HABITAT ARCHITECTURAL REVIEW BOARD

TABBY ROADS

August 15, 2022

Court Atkins Group (on behalf of Leslie and Jeffrey Crook)
Lot 31, 6 Shell Rake, Bluffton, South Carolina 29910

Fig 1 – Southwest Corner Trees

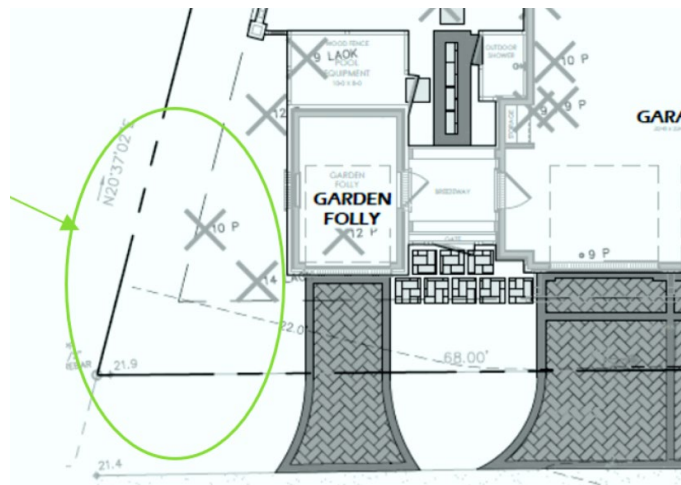
- As a part of the preliminary review, HARB informed applicant that the large laurel oak and pines in the southwest corner should not be removed. In the submitted landscape plan they are removed. As a condition of approval, the pine (10P) and laurel oak (14 LAOK) shown in Fig 1 shall remain intact. We recommend that region of the Lot be left undisturbed (encircled region denoted in Fig 1). HARB requests steps be taken to reduce the impact specifically to the laurel oak to increase the longevity of its life span.
